RE: P.Z. 02-2024 18009 and 18045 N. Outer 40 Rd. (Gumbo Flats Properties, LLC): A request for an ordinance amendment to create a new "PI" Planned Industrial District for two parcels zoned "M3" Planned Industrial District, "NU" Non-Urban District and "PI" Planned Industrial District, and totaling 78.07 acres located on the north side of Outer 40 Road (16W310045 and 16W240041).

Planning Commission Staff Report

Petition: **P.Z. 02-2024 18009 and 18045 N. Outer 40 Rd. (Gumbo Flats Properties, LLC)**: A request for an ordinance amendment to create a new “PI” Planned Industrial District for two parcels zoned “M3” Planned Industrial District, “NU” Non-Urban District and “PI” Planned Industrial District, and totaling 78.07 acres located on the north side of Outer 40 Road (16W310045 and 16W240041)

PRELIMINARY DEVELOPMENT PLAN

Sheet Title:	Gravel Parking Lot Landscape Plan
Sheet No.:	L1.02
Date:	1/25/24
Job #:	813.127

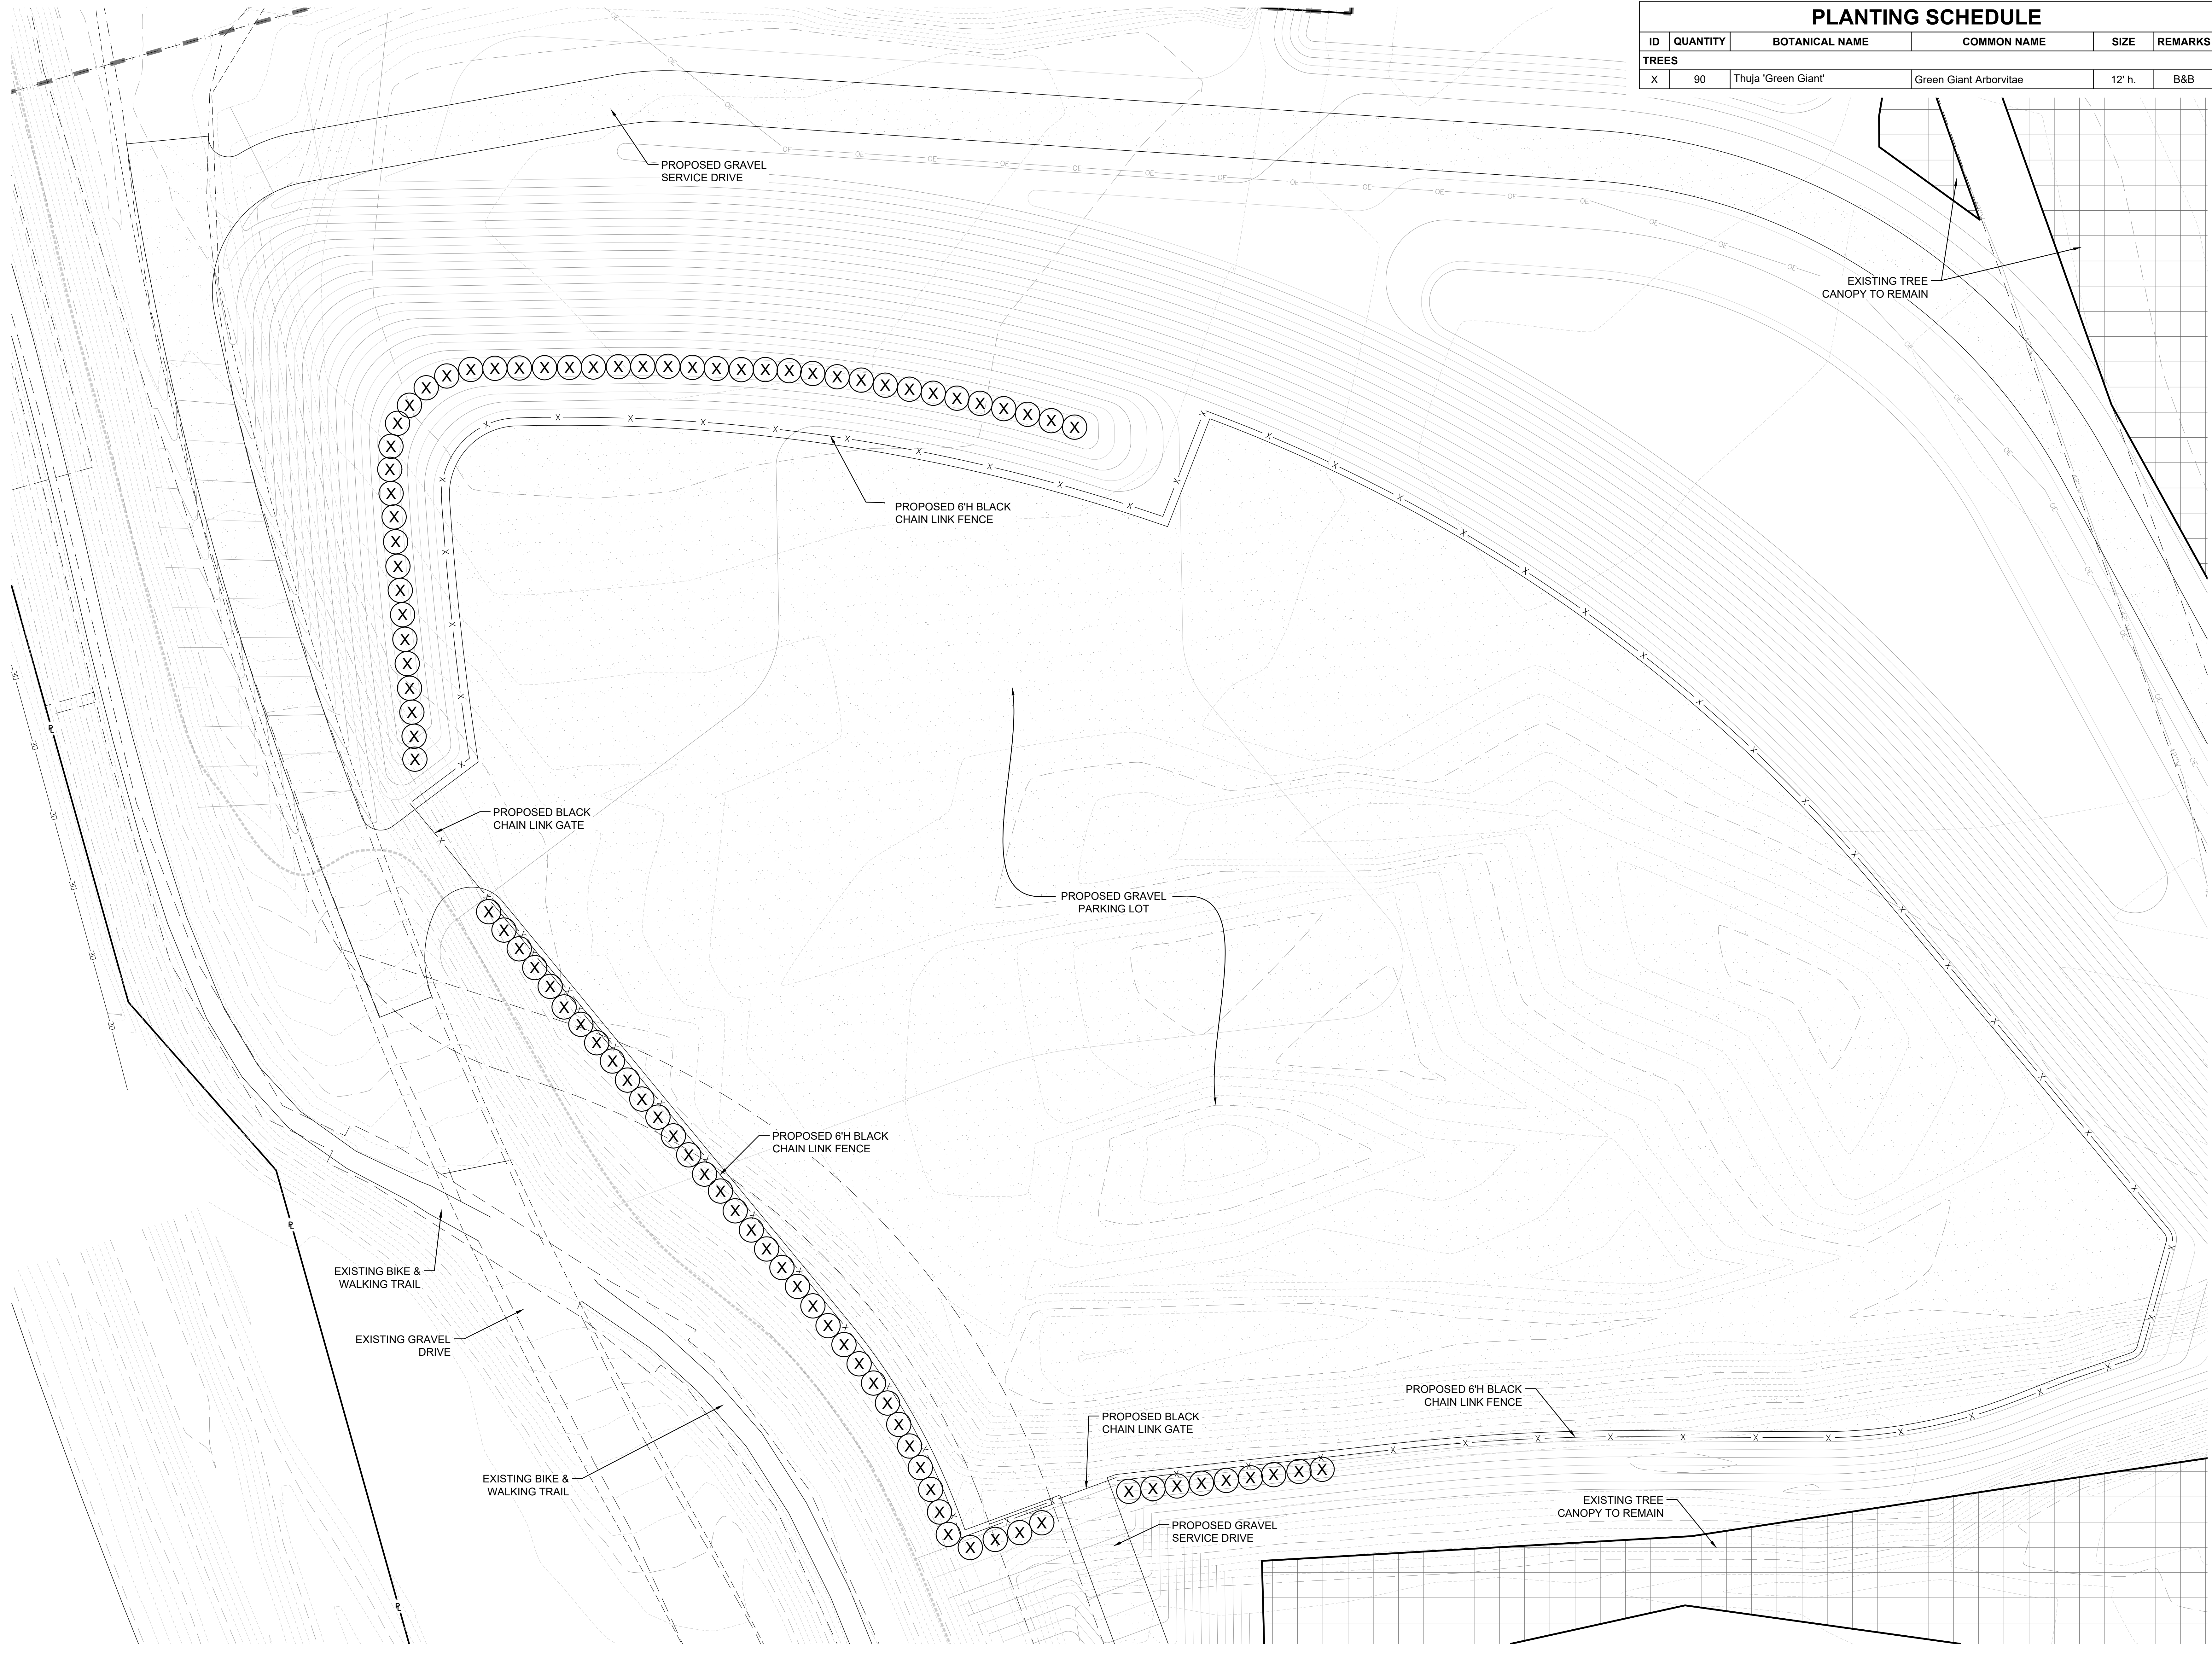
Concerns were raised regarding the visual impact of the proposed parking area. Provide information on how the development team will be addressing this concern.

1. Concerns were raised regarding the visual impact of the proposed parking area. Provide information on how the development team will be addressing this concern.

Response: Applicant provided architectural renderings/perspectives from the north and the south. These depict the proposed perimeter landscaping around the perimeter of the parking area and the elevation of the parking area as seen from the highway entering and exiting the City. The parking area is constructed 6'-8' below the top of the levee trail and not visible from westbound I-64. Applicant has added a landscape berm and perimeter landscaping to further shield the view from eastbound I-64.

Response: Enclosed are architectural renderings/perspectives from the North and the South. These depict the proposed perimeter landscaping around the perimeter of the parking area and the elevation of the parking area as seen from the highway entering and exiting the City. The parking area is constructed 6'-8' below the top of the levee trail and not visible from westbound I-64. We have added a landscape berm and perimeter landscaping to further shield the view from eastbound I-64.
